REVISED PERC CERT

PERCOLATION CERTIFICATION PLAN: "12013 BROAD MEADOW LANE"

PLAT # PCS37807 - REV

PURPOSE OF REVISION: TO ALLOW FOR ADDITION.

LOCATION DIAGRAM

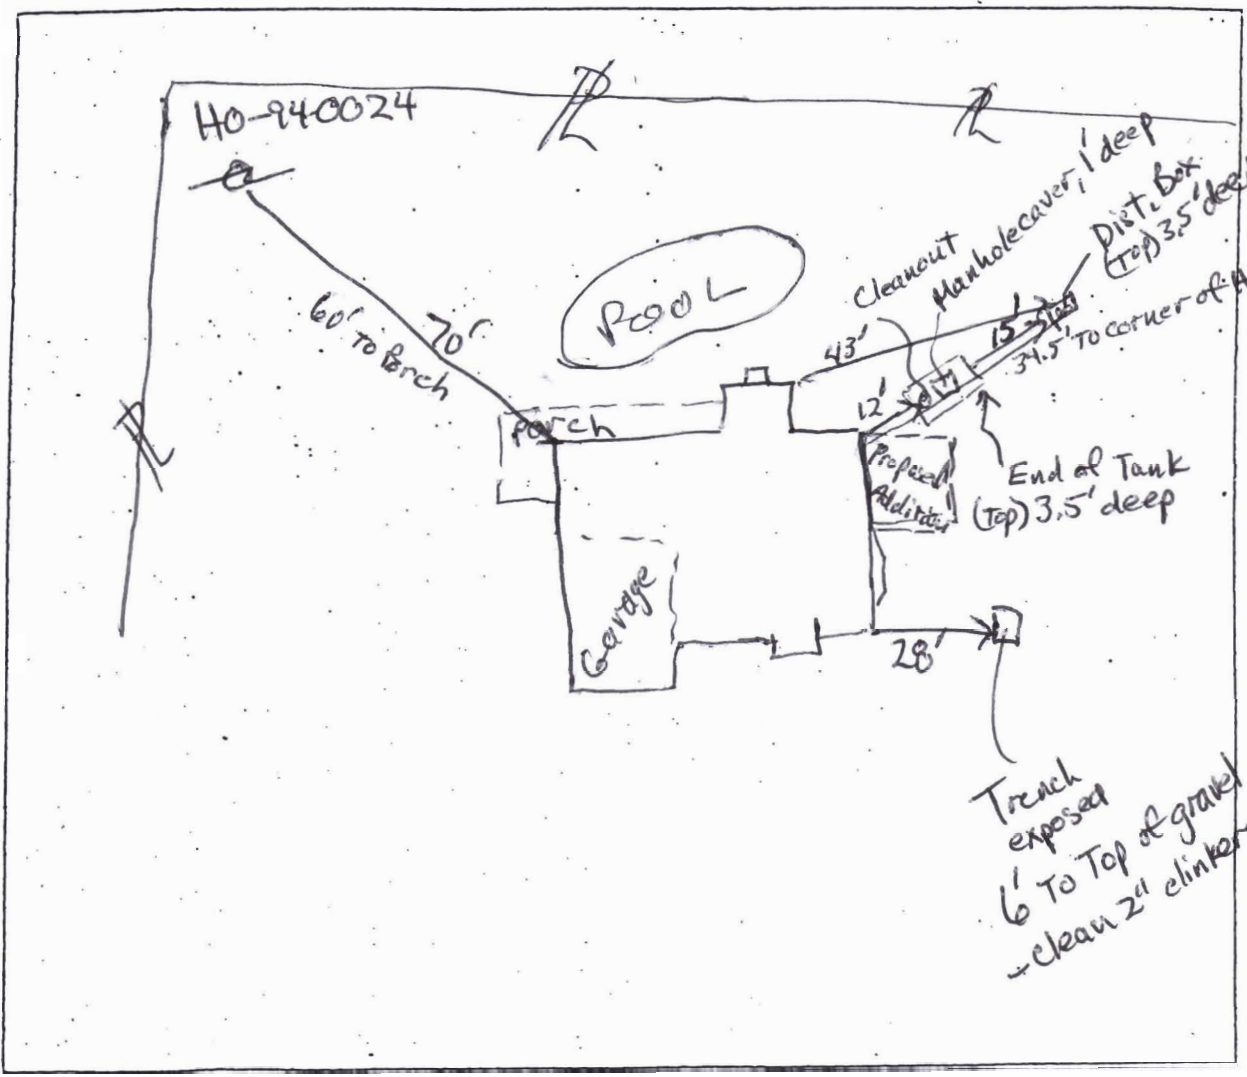
PROPOSAL: Locate Distribution box and Top Trench in relation to proposed addition.

COMMENTS: No evidence of sewage overflow or system failure.

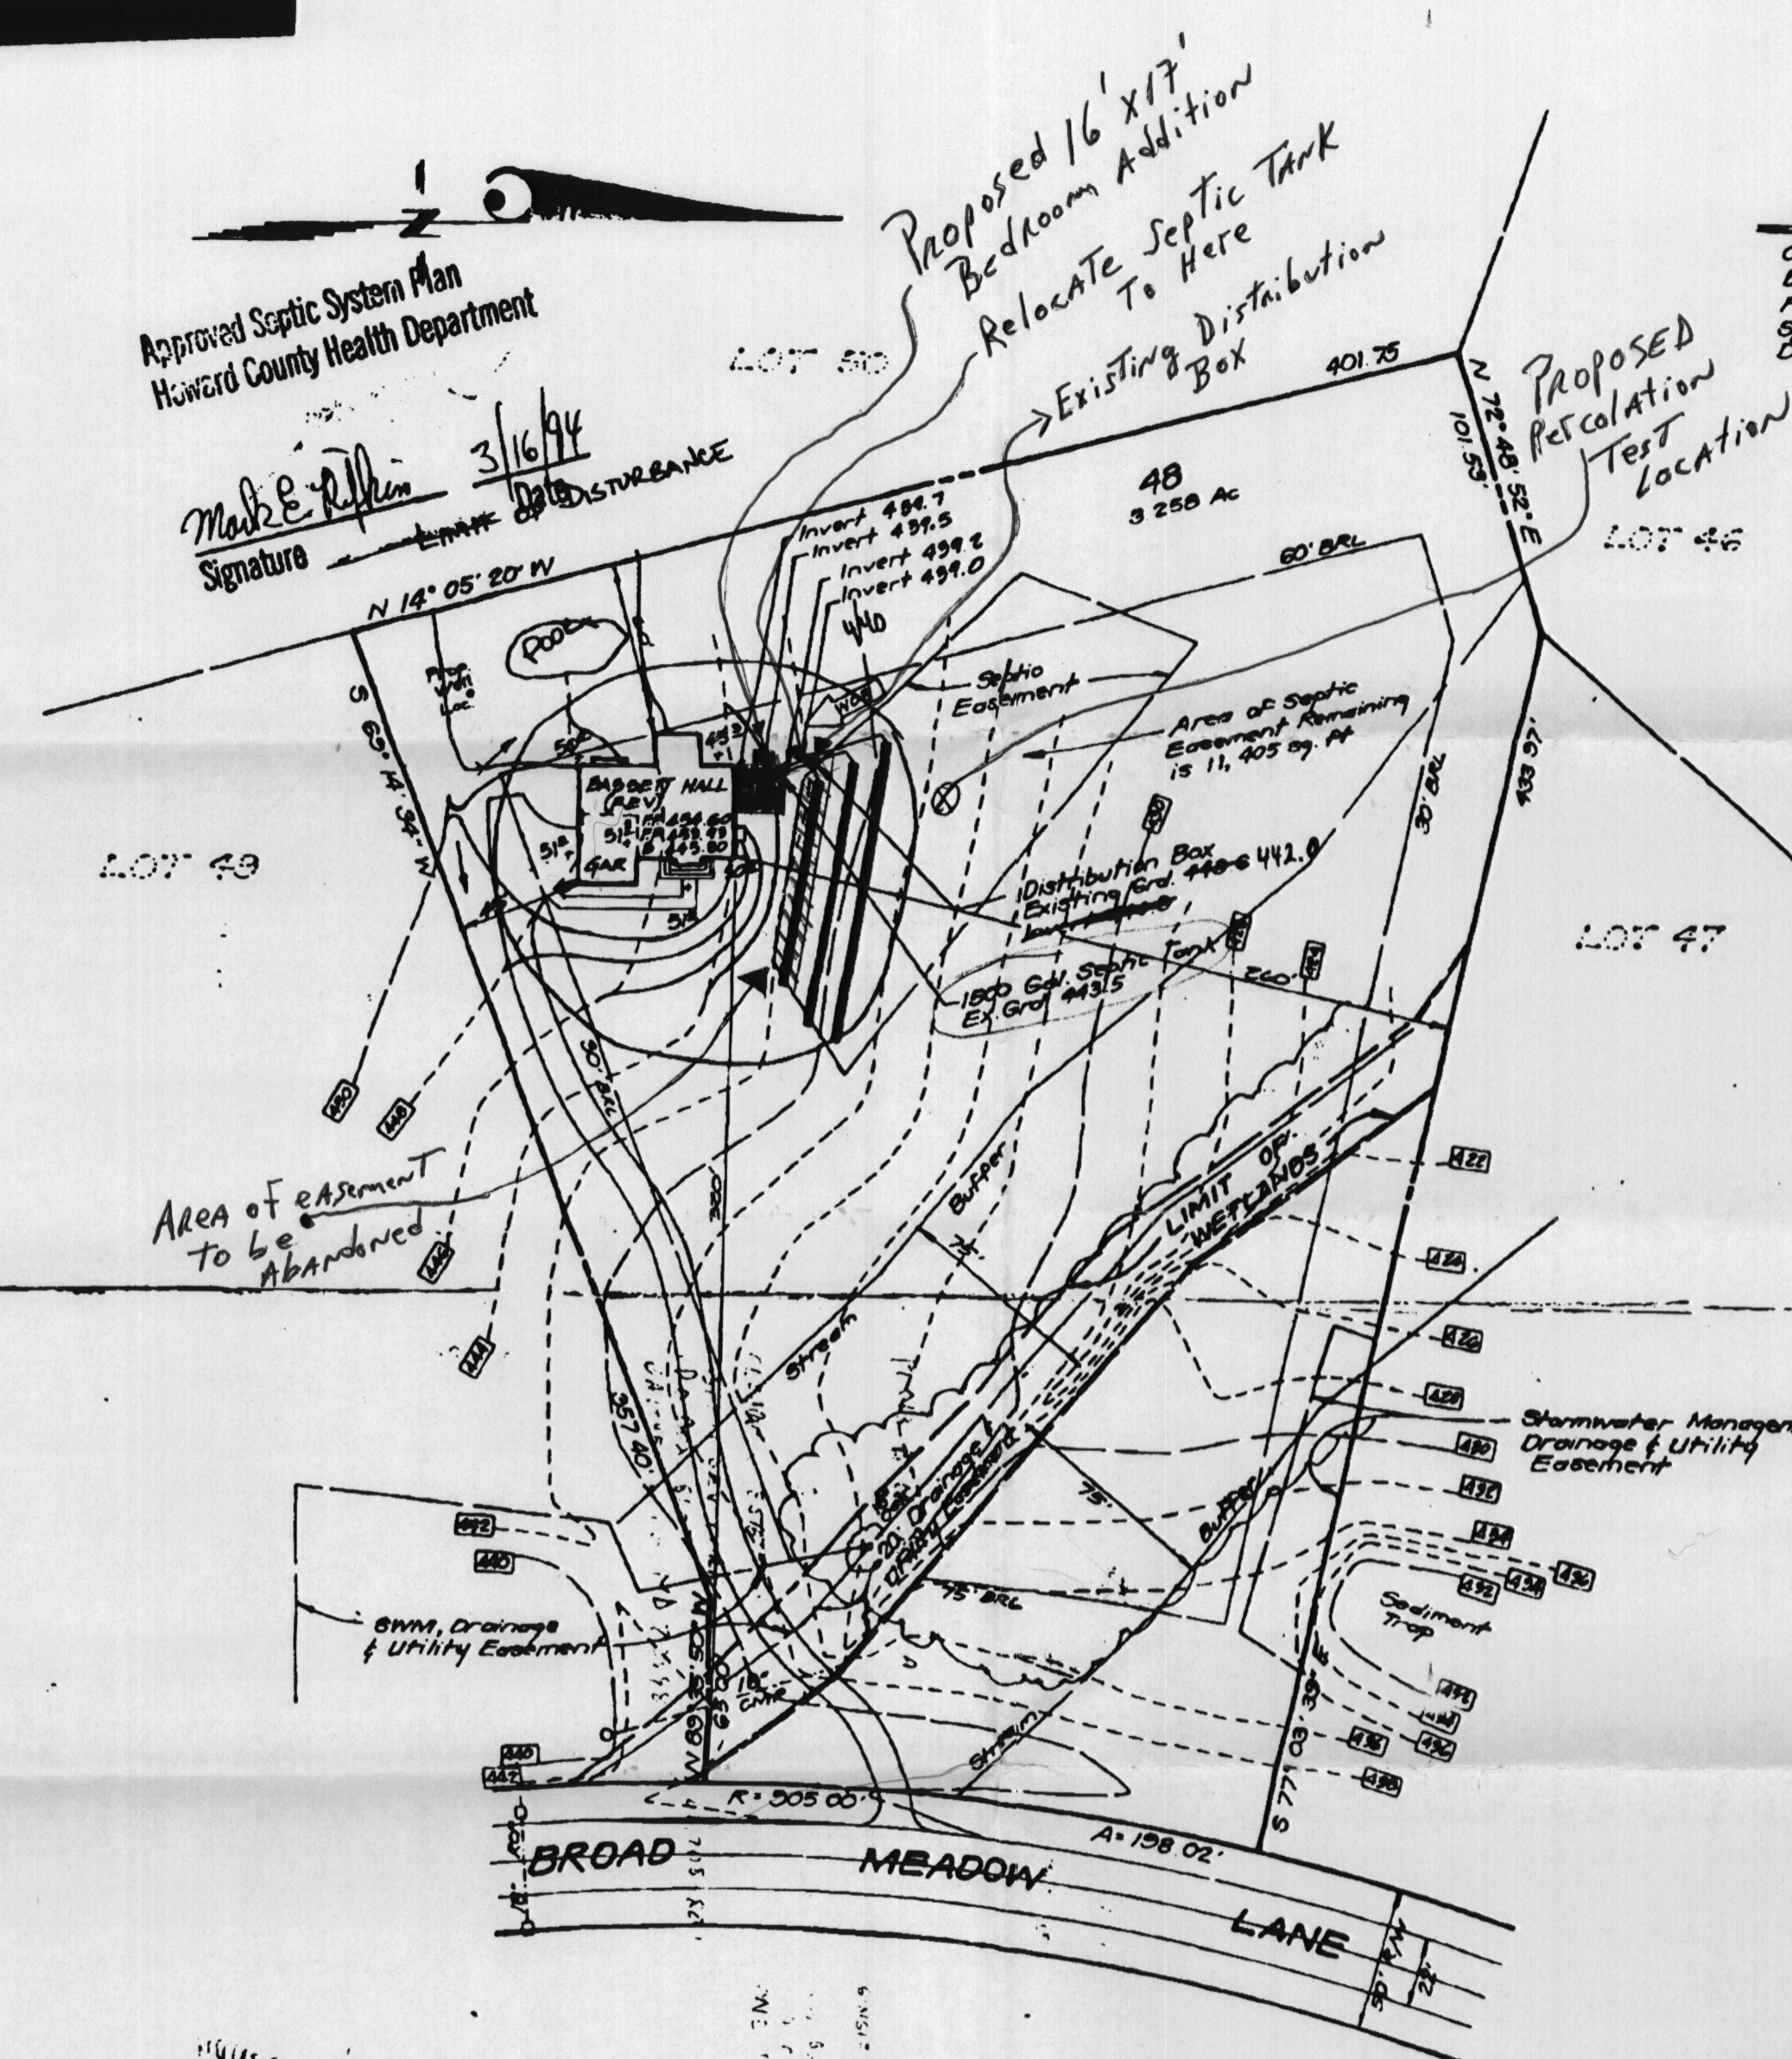
EXISTING SEPTIC TANK IS TO BE ABANDONED.

- THE EXISTING SEPTIC TANK WILL BE RELOCATED AT LEAST 10 FEET FROM A STAKED CORNER OF THE PROPOSED ADDITION. THE REPLACEMENT TANK WILL HAVE CAPACITY OF 2000 GALLON.

- THE TOP DRAINFIELD LINE WILL BE PROPERLY ABANDONED AT THE DISTRIBUTION BOX AT THE TIME THE SEPTIC TANK IS REPLACED. HEALTH DEPARTMENT DESIGN CALCULATIONS REFLECT THAT THE REMAINING 160 LINEAR FEET OF TRENCH IS ADEQUATE FOR THE RESIDENCE RESULTING FROM THE PROPOSED ADDITION.

- A PERCOLATION TEST WILL BE CONDUCTED IN THE CENTER OF THE EASEMENT AT TIME THAT SEPTIC TANK IS REPLACED.
- THE LOT SHOWN HEREON COMPLIES WITH THE MINIMUM OWNERSHIP WIDTH AND LOT AREA AS REQUIRED BY THE MARYLAND DEPARTMENT OF ENVIRONMENT.

- ANY CHANGES TO A PRIVATE SEWAGE EASEMENT SHALL REQUIRE A REVISED PERCOLATION CERTIFICATION PLAN.
- APPROXIMATELY 1125 SQUARE FEET OF UTILIZED SEPTIC EASEMENT ARE BEING ABANDONED BY THIS REVISED PERCOLATION CERTIFICATION PLAN.
